**SOUND TRANSIT LYNNWOOD LINK EXTENSION**

**PREFERRED ALTERNATIVE  
NE 145TH STREET STATION  
SITE PLAN**

DWG NO. N13-AAP001

**PLAN #1**

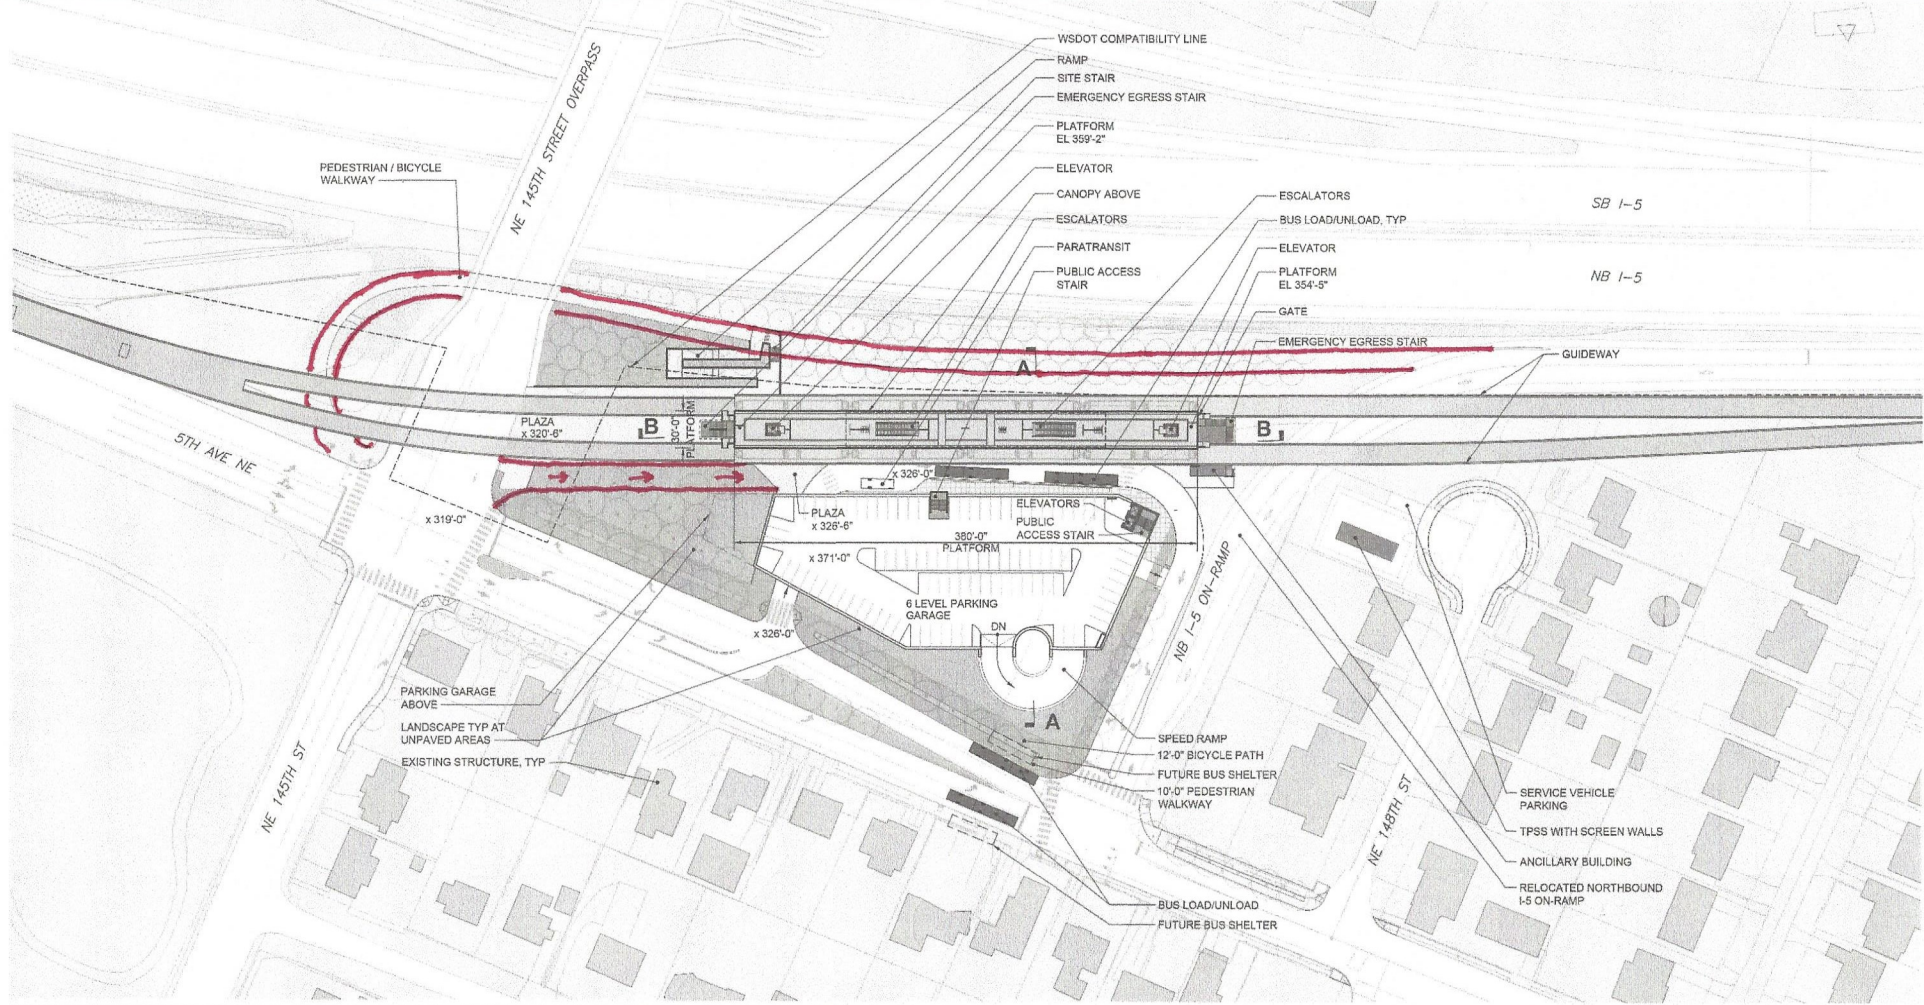
My first plan (Plan #1) is the least expensive and simplest plan, but still should provide a huge improvement in traffic flow around the station. Plan #1 involves adding a second entrance (Let's call it 145<sup>th</sup> ST-ENTER) to the parking garage and station, which would be located just west of 5<sup>th</sup> Ave NE with the actual entrance located on 145<sup>th</sup> St. See the PLAN #1 DRAWING attachment. The elevations on the original site plan and the Sound Transit drawings of the station indicate that the landscaped area south of the parking garage will be about the same elevation as 5<sup>th</sup> Ave. This is necessary for Plan #1 because the new 145<sup>th</sup> ST-ENTER entrance will be located on that landscaped area. All traffic from both directions on 145<sup>th</sup> St. and north bound traffic from 5<sup>th</sup> Ave. NE south of 145<sup>th</sup> St. would be required to use 145<sup>th</sup> ST-ENTER to enter the station. The original left-turn-only lane for turning into 5<sup>th</sup> AVE-ENTER would no longer exist. Something to prevent north bound traffic on 5<sup>th</sup> Ave from using 5<sup>th</sup> AVE-ENTER would need to be installed. Only south bound vehicles on 5<sup>th</sup> Ave. NE would be allowed to enter the original 5<sup>th</sup> AVE-ENTER. This would eliminate the bottle-neck caused by 5<sup>th</sup> Ave. north bound vehicles trying to enter 5<sup>th</sup> AVE-ENTER by crossing the south bound lane of vehicles waiting to enter 145<sup>th</sup> St. (South bound traffic on 5<sup>th</sup> Ave. backed up to enter 145<sup>th</sup> St. is a phenomenon existing today during rush hour). However, north bound traffic on 5<sup>th</sup> Ave. from 145<sup>th</sup> St. could still enter the NB I5 ON-RAMP right next to the station exit currently depicted on the original site plan (PLAN #1 DRAWING), but a traffic light would be required there. The City agrees it is feasible to allow buses and cars travelling east on the 145<sup>th</sup> St. bridge to exit to the right after crossing the bridge, then loop under the bridge and enter the NB I5 ON-RAMP by that route (Let's call it the Loop Rd). This is similar to the pedestrian/bicycle walkway on the original site plan. Loop Rd. would also be part of Plan #1, but is just roughly sketched in on the PLAN #1 DRAWING.

The NB I5 ON-RAMP and station exit just north of the parking garage are probably too close to the 5<sup>th</sup> Ave. station entrance and 145<sup>th</sup> St. however, and should be moved further north. That could be achieved in Plan #2.

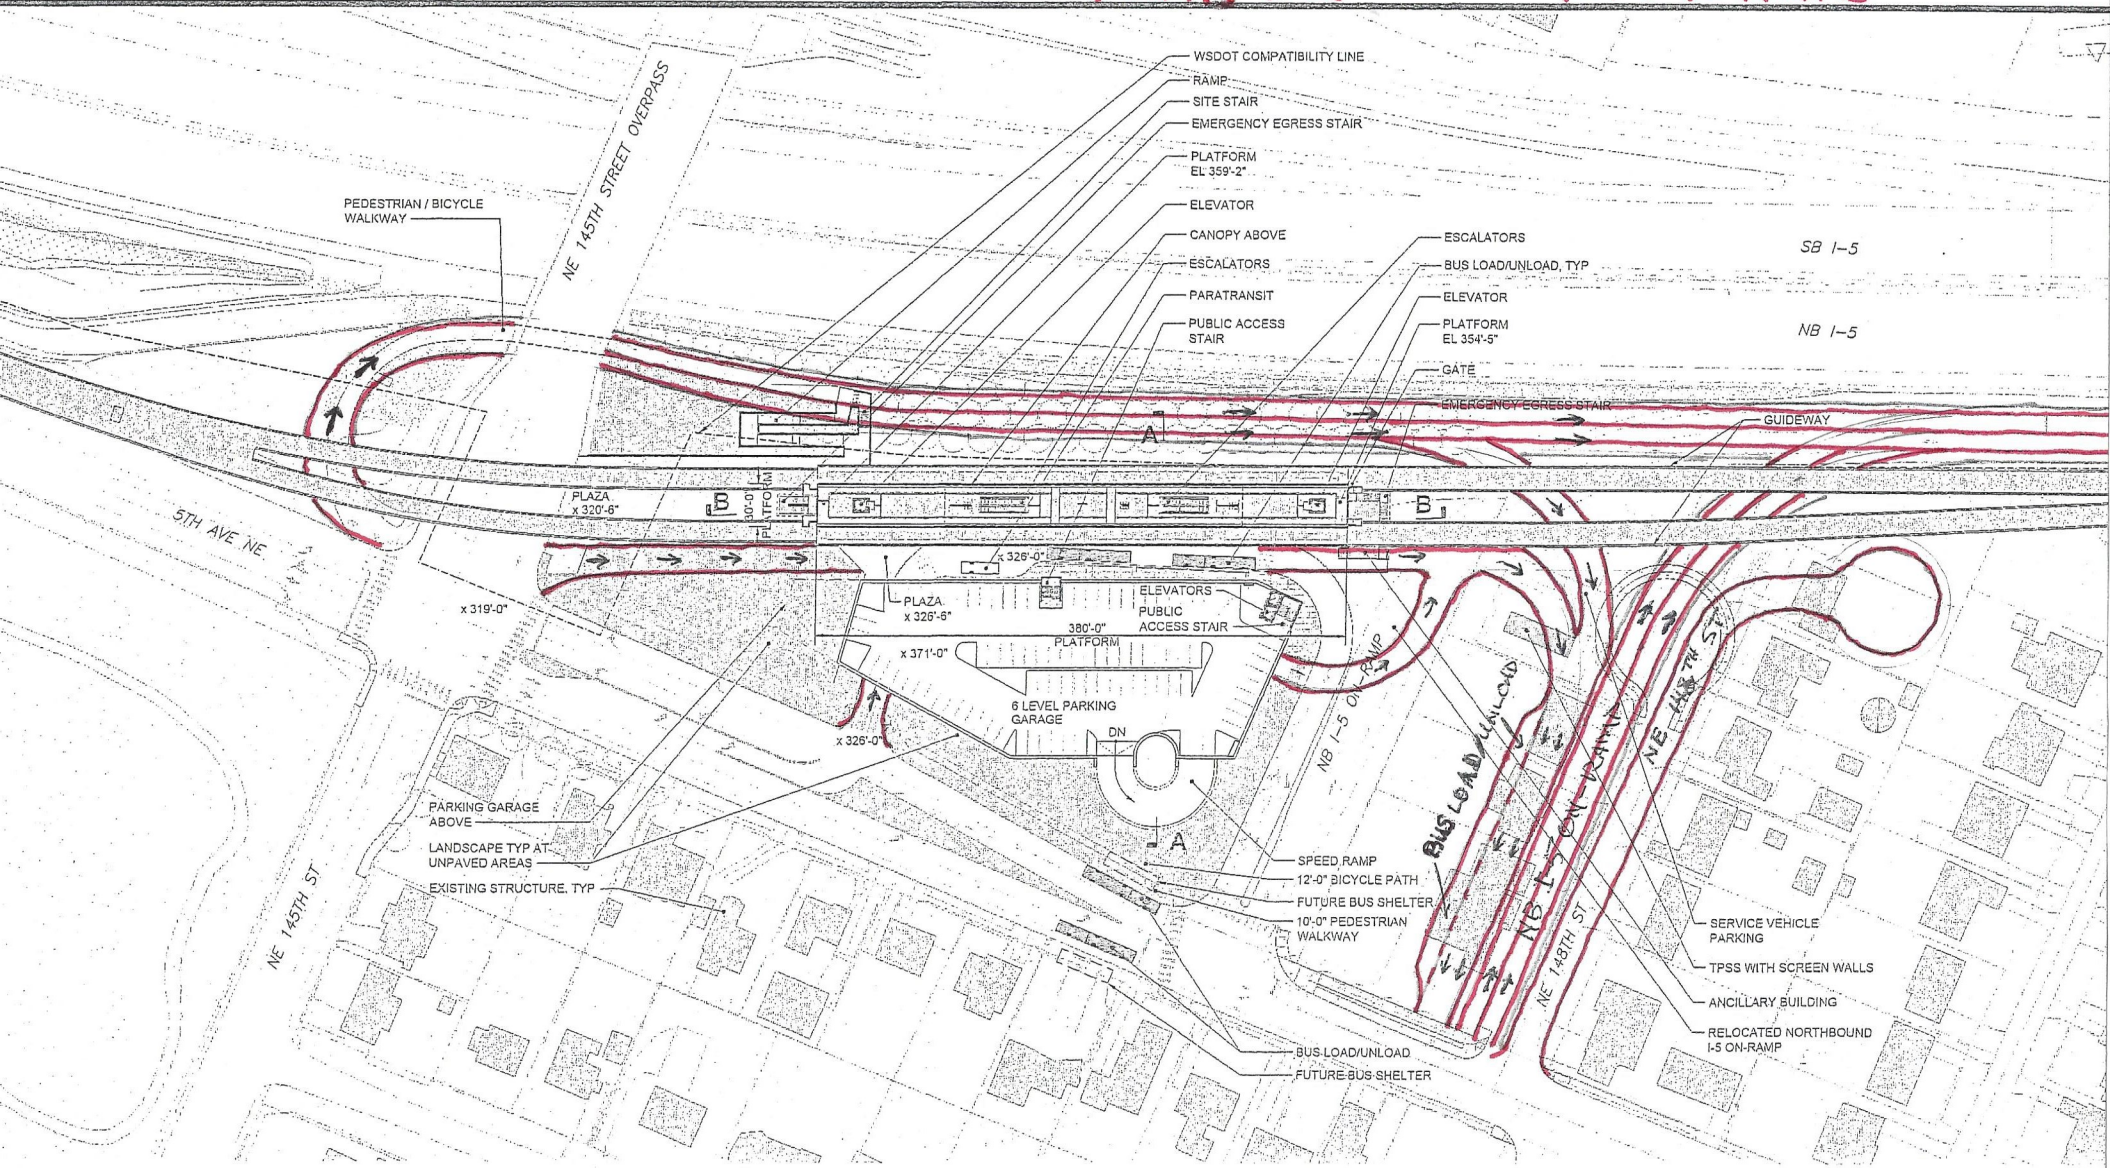
The addition of the extra entrance 145<sup>th</sup> ST-ENTER would greatly improve traffic flow, but my second plan (Plan #2, which still uses 145<sup>th</sup> ST-ENTER) would improve traffic flow even more and add other amenities to the station area. Plan #2 is depicted in the PLAN #2 DRAWING attachment. Although it

would be more expensive, it would pay dividends by making the station area more desirable for future development. More about that later. As stated in Plan #1, the City agrees it is feasible to allow buses and cars travelling east on the 145<sup>th</sup> St. bridge to exit to the right after crossing the bridge, then loop under the bridge and enter the NB I5 ON-RAMP by that route, which we've called Loop Rd. The big difference between Plan #2 and Plan #1 above is that in addition to the just mentioned use of Loop Rd., Plan #2 provides a second choice drivers can make once on the Loop Rd. That is, they can exit from the Loop Rd. before they enter the NB I5 ON-RAMP, drive under the tracks onto a street (Let's call it EXIT St.) parallel with NE 148<sup>th</sup> St. and about 20 feet south of it. The NB I5 ON-RAMP on the original ST plan has been moved about 170 feet north of its original location to immediately south of NE 148<sup>th</sup> St. Then EXIT St. replaces the exit from the station on the original plan and EXIT St. is just south of the new NB I5 ON-RAMP. There are three traffic sources feeding EXIT St.: the parking garage, all cars and buses that entered the two station entrances (5<sup>th</sup> AVE-ENTER and 145<sup>th</sup> ST-ENTER), and the vehicles from the Loop Rd. all merging into EXIT St. There would be a pullout on the south side of EXIT St. for buses, cars, and taxis to pick up and drop off passengers. Those passengers would be a short walk from the station which could be covered and well lit. This would be the kiss-and-ride location in the case of cars. Since buses would either drop passengers here on EXIT St. or at the station's door, entering through one of the station's two entrances, the pedestrian path underneath the bridge would no longer be needed and it can be eliminated. The few pedestrians walking on the south side of 145<sup>th</sup> St bridge could more safely use the cross walks at the 5<sup>th</sup> Ave. and 145<sup>th</sup> St. intersection anyway for security reasons, especially at night. Bikes could use the Loop Rd. if riding in traffic across the bridge or cross the freeway on the ped-bike bridge on the north edge of the motorized bridge. Eliminating this pedestrian path under the bridge would provide more space for Loop Rd. to accommodate vehicles choosing to exit onto EXIT St. This Loop Rd. should be two lanes after it proceeds from under the bridge. The left lane would only be used for the I-5 on ramp and the right lane could be used for that too or to turn off to EXIT St.

Unless there are technical reasons I'm unaware of, at the very least, something like Plan #1 should be done to avoid grid-lock near the station. If funding could be found, if it's technically possible, if it wouldn't violate Shoreline principles, and if it's legal; I think some variation of Plan #2 should be considered too. I will list some of the pros and cons of Plan #2:

1. Three separate entry points to the station area for pick-up and drop-off of passengers for buses and cars. No one entry point will have to carry the entire load so there'll be less traffic volume in each location, vastly reducing the waiting time required for buses and cars to pass through.

2. There are two entry points for cars using the parking garage instead of just one. This will reduce congestion and backup lines on the streets of cars waiting in line to enter the station complex.

3. The bottle-neck at the original 5<sup>th</sup> AVE-ENTER has been removed. Much of the traffic otherwise on 5<sup>th</sup> Ave. has been moved elsewhere.

4. More space on 5<sup>th</sup> Ave. for north bound vehicles to wait to turn left on to the NB I5 ON-RAMP.
5. Many of the tall trees in the current park-and-ride possibly could be saved in the area between the parking garage and EXIT St., which could be a signature of this Station and depicted as being in keeping with the Shoreline Logo. There may be enough space for a few shops and a restroom. It could be a parklike place to sit and hang out. It would be much less noisy than the landscaped unpaved areas and plaza on the original site plan.

6. Provides a better location for kiss & ride.

7. More options and locations for buses to service the Station, which lessens the time buses must spend there.
8. Cars can enter the parking garage at a faster rate.
9. Less time spent for buses and cars to enter the Station area means less fuel consumption.

1. This plan requires more infrastructure and buying 3 or 4 houses, but is probably well worth it, given the added benefits.
